RE: Velasquez Residence
8701 Glendale NE
Grading & Drainage Plan
Engineer's Stamp Date: 11/5/24
Hydrology File: B20D069

Based upon the information provided in your submittal received 11/05/2024, the Grading & Drainage Plan **is not approved** for Building Permit. The following comments need to be addressed for approval of the above referenced project.

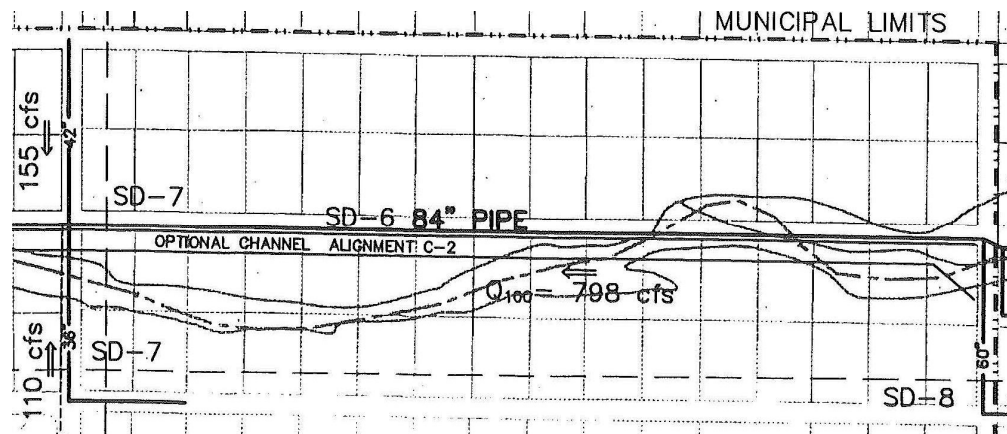
1. Per the IDO, the property owner of the property is responsible for building the adjacent half of Glendale Ave. NE to include curb & gutter, and sidewalk. The project will have to go to the Development Facilitation Team (DFT) for approval of the Infrastructure List. Also, half of an 84" storm sewer (see below) will also need to be added to the Infrastructure List. The storm sewer was called out in the NAA MDP.

ENGINEER'S SEAL	LOT 24 BLK 16 U 3 NAA 8701 GLENDALE AVE. NE	DRAWN BY DEM
	GRADING AND DRAINAGE PLAN	DATE 11-1-24
		8701 Glendale Ave NE, DWG
	 <i>Rio Grande Engineering</i> PO BOX 53924 ALBUQUERQUE, NM 87199 (505) 321-9099	SHEET # C1
		JOB # _____
DAVID SOULE P.E. #14522

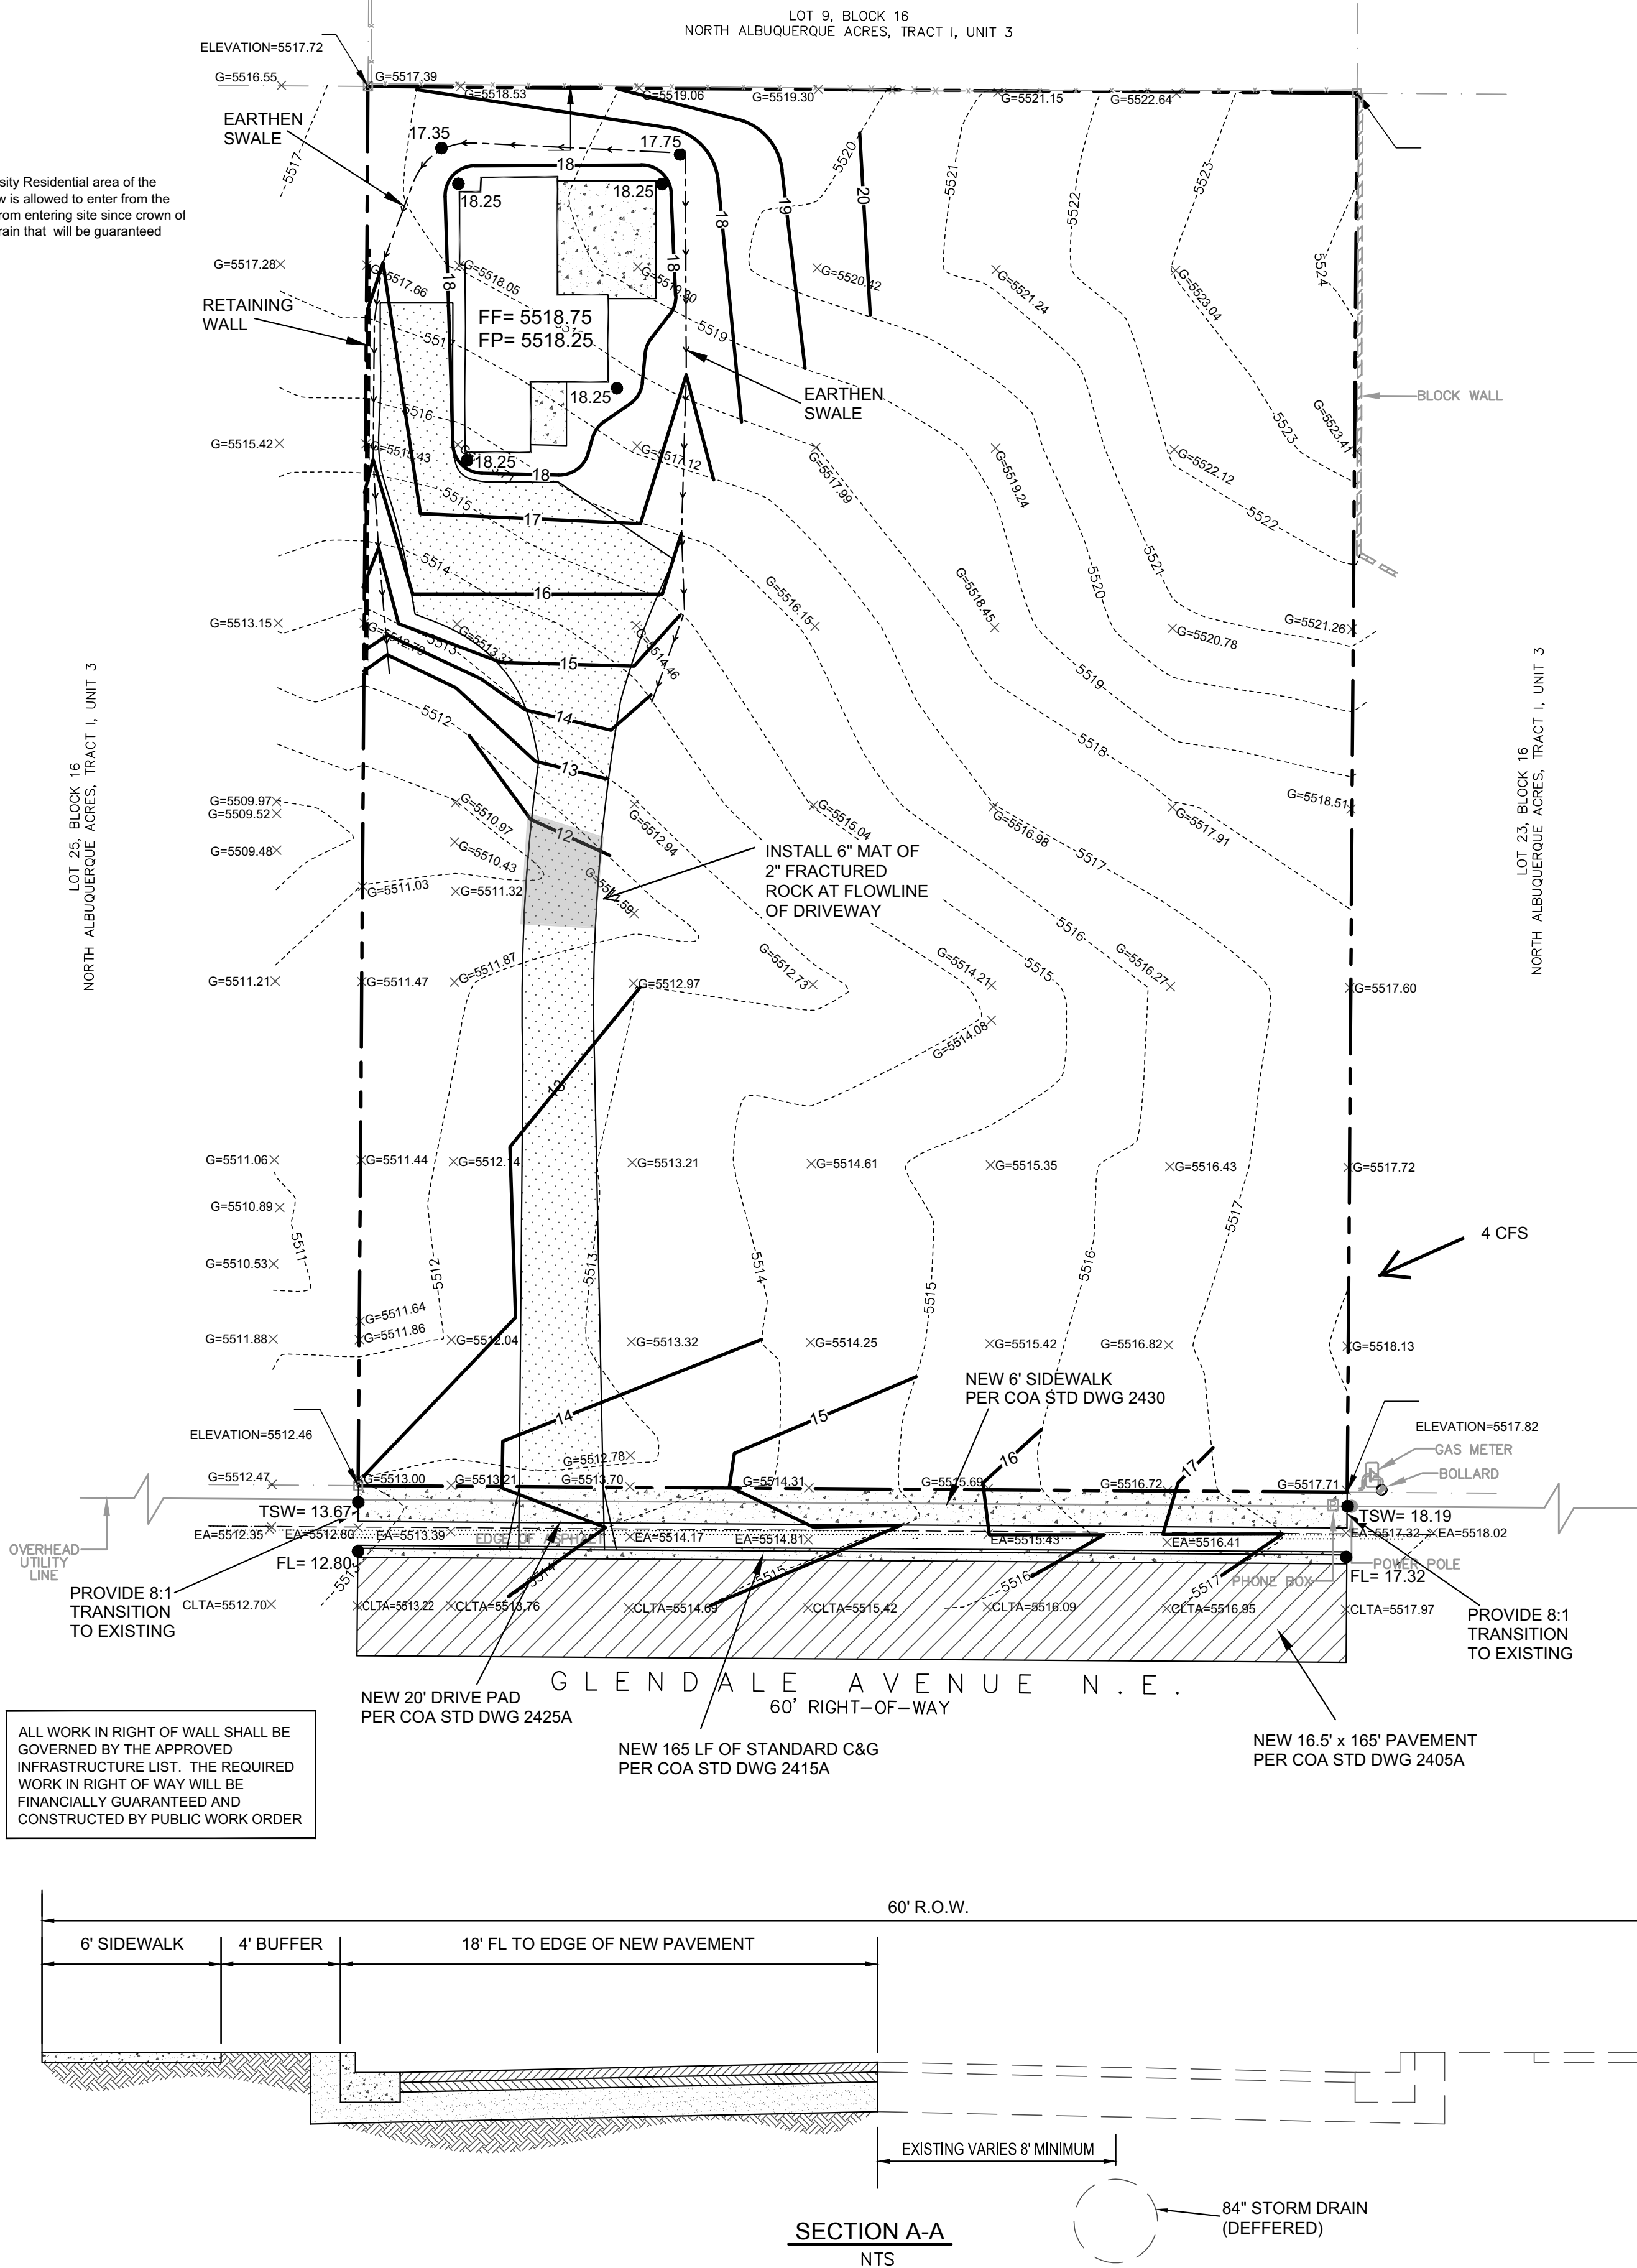
2. These improvements will need to be shown on the Grading & Drainage Plan.
3. Properly showing and calculating the existing drainage that goes in the natural arroyo and Glendale from the east to the west needs to be done. This existing drainage needs to be

allowed to go through the property and can be managed somehow in the proposed development.

4. Provide management onsite for the Stormwater Quality Volume (SWQV) in accordance with the new drainage ordinance, § 14-5-2-6 (H). Please show the top and bottom of the ponds along with the volume for each pond. The onsite drainage should be directed to these ponds prior to being collected in a private unground drainage system. Please follow the DPM Article 6-12 Stormwater Quality and Low-Impact Development for the sizing calculations. To calculate the required SWQV, multiply the impervious area draining to the BMP by 0.42 inches for new development sites and 0.26 inches for redevelopment sites. The calculations of both the required and the provided volume of each BMP must be shown on the Grading and Drainage Plan. Each BMP should be labeled on the Grading and Drainage Plan with the required SWQV and associated water surface elevation and the 100-year water surface elevation. Landscaping of surface BMPs is also required to be noted on the Grading and Drainage Plan.

5. Provide the existing and proposed grades on both sides of the proposed retaining wall.
6. Provide sections through all external boundaries showing proposed retaining walls, garden walls, property/ROW lines, existing and proposed grades. In accordance with DPM Ch.22, section 5 part B, grading and wall construction near the property line may not endanger adjacent property or constrain its use.
